Docket No. 50-423
B13678

Attachment 2

Millstone Nuclear Power Station, Unit No. 3
Proposed Technical Specification Changes
Cycle 4

December 1990

FIGURE 3.1-1
REQUIRED SHUTDOWN MARGIN FOR MODE 3 WITH FOUR LOOPS IN OPERATION

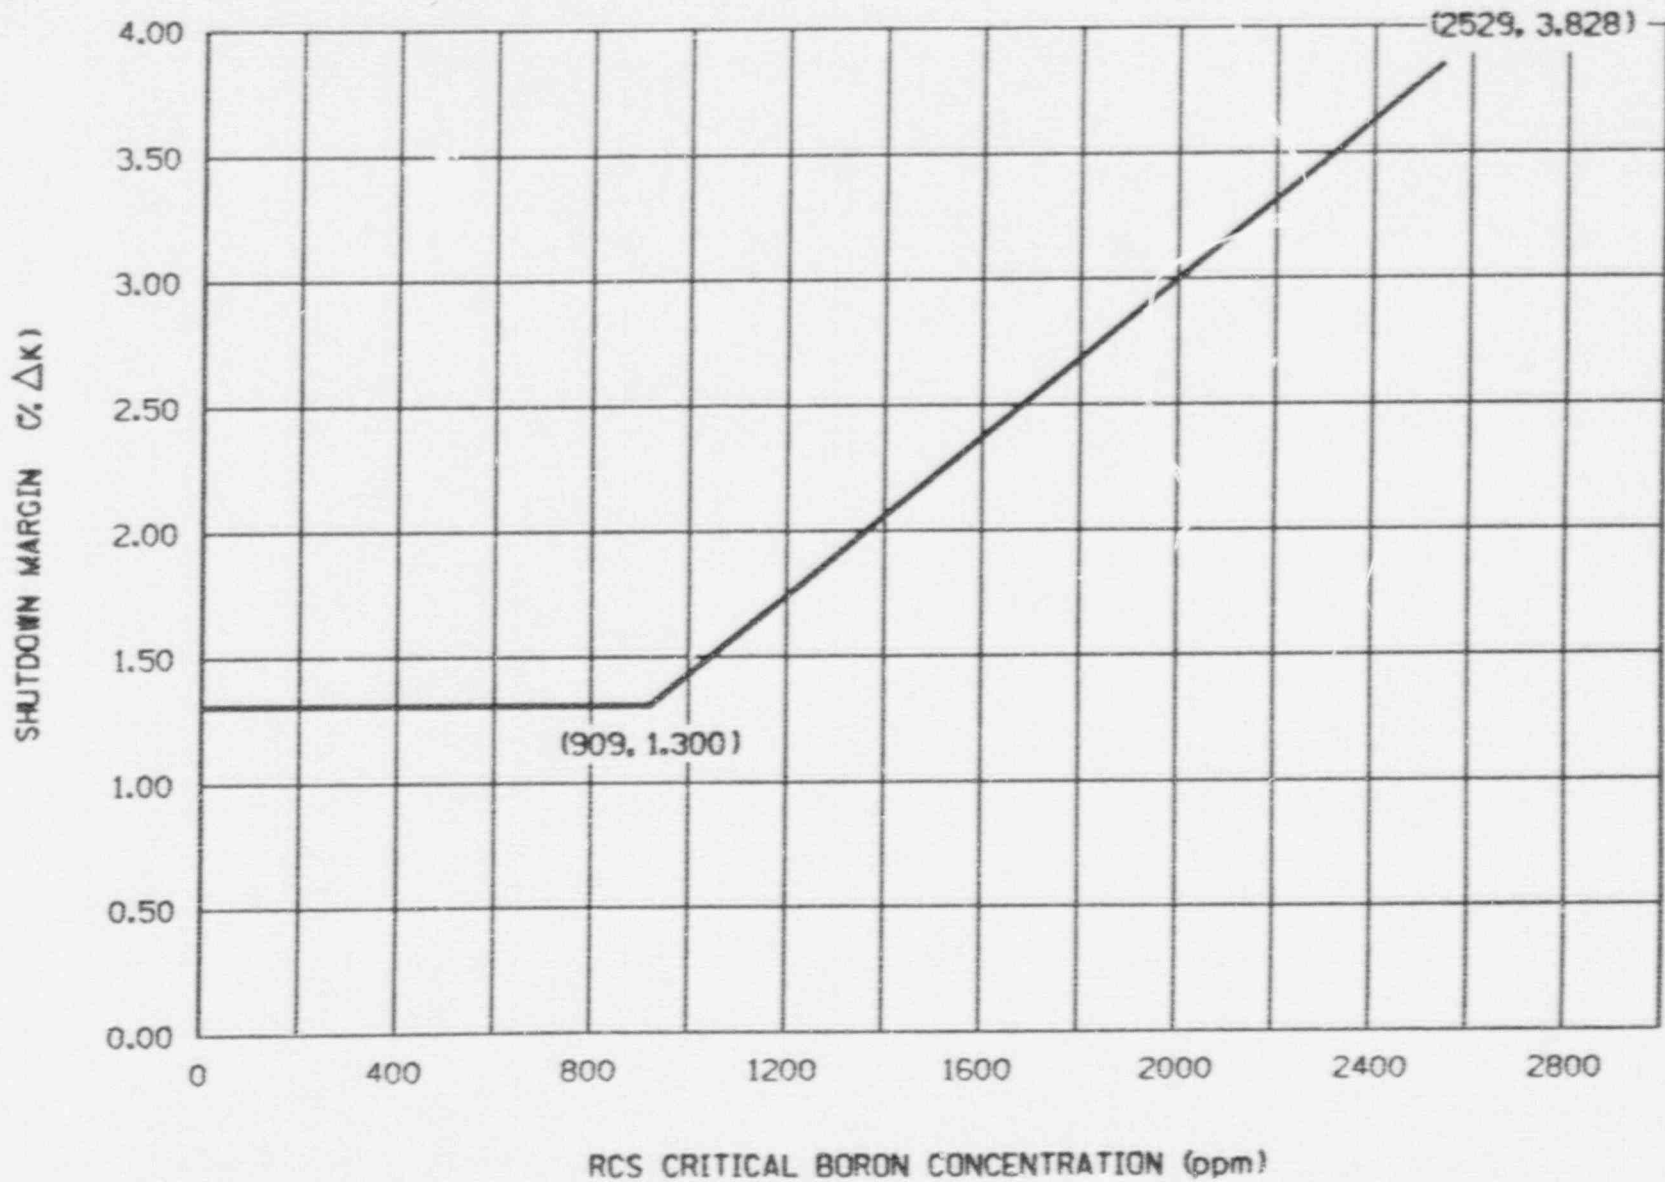
3.1.1.1.2 The SHUTDOWN MARGIN shall be greater than or equal to the limits shown in Figures 3.1-1, 3.1-3 and 3.1-4 for four loop operation and in Figure 3.1-2 for three loop operation.

FIGURE 3.1-4
REQUIRED SHUTDOWN MARGIN FOR MODE 5 WITH RCS LOOPS FILLED

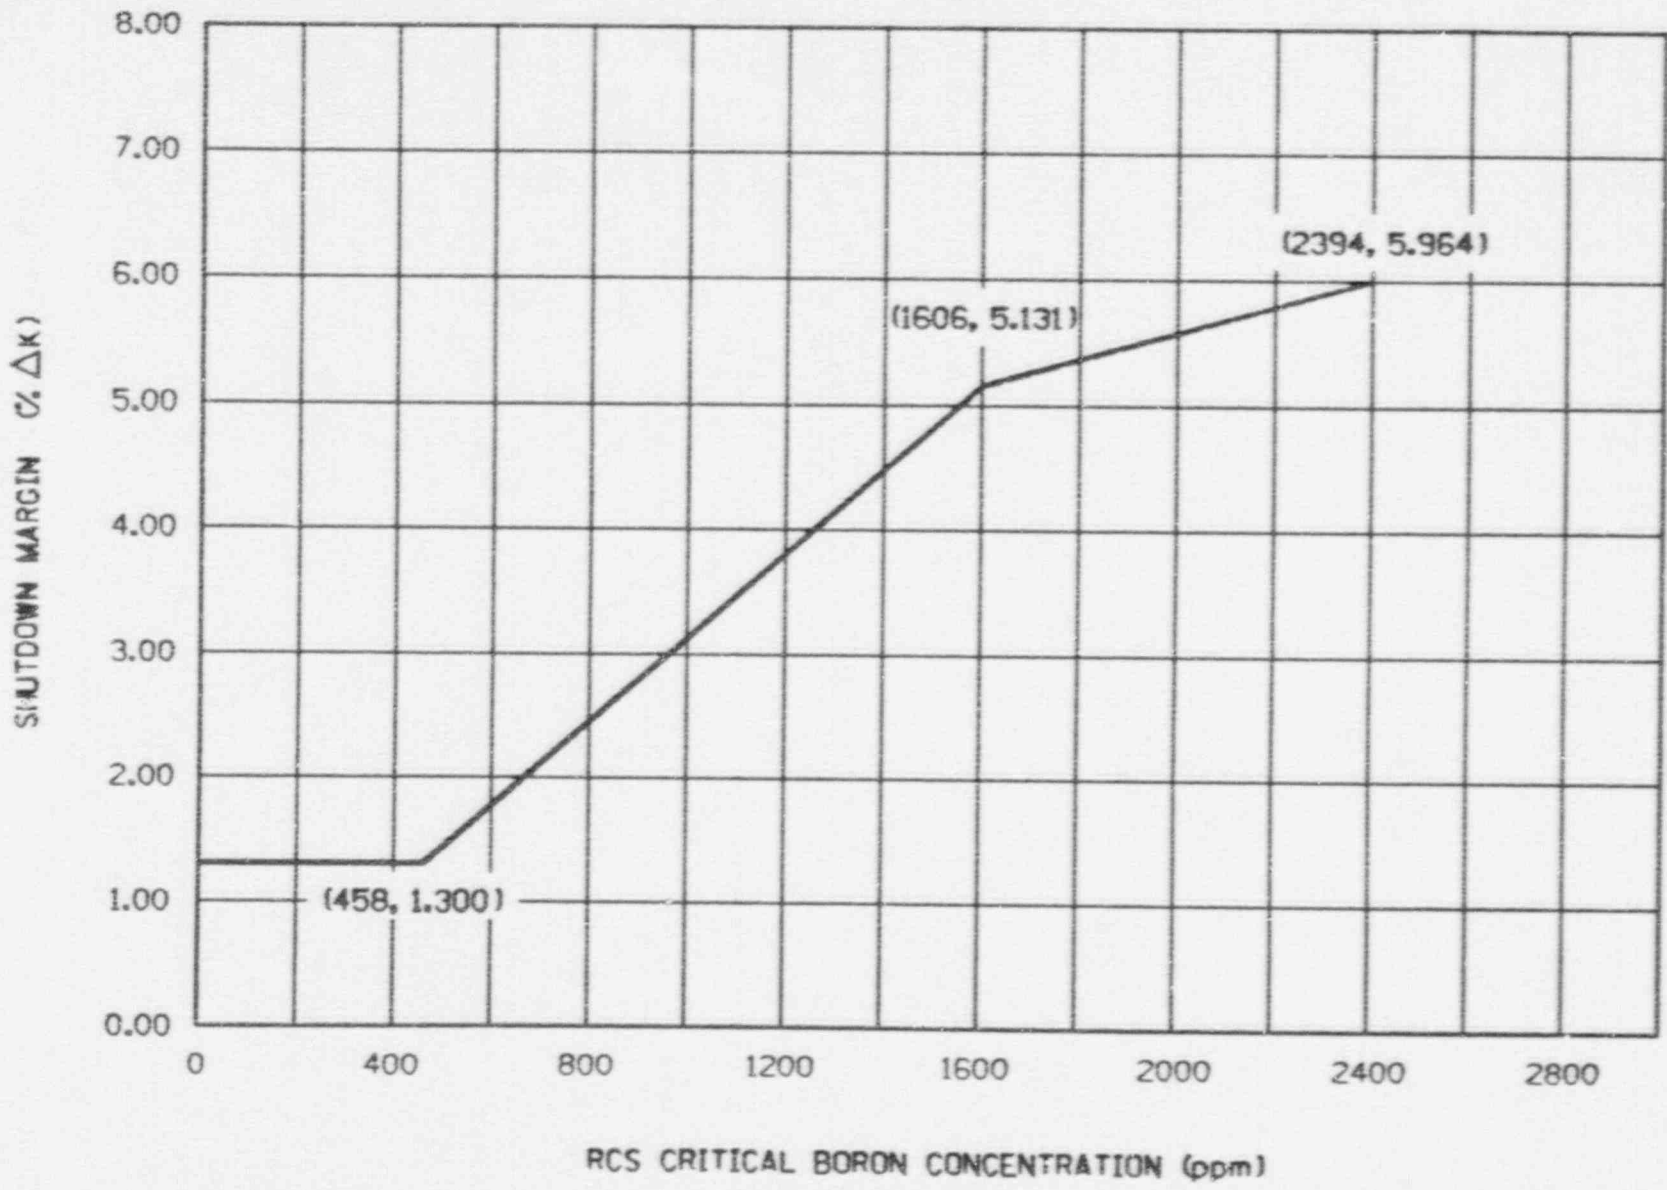
- a) the limits shown in Figure 3.1-5 or
- b) the limits shown in Figure 3.1-4 and secure the valves shown in Specification 4.4.1.4.2.3.
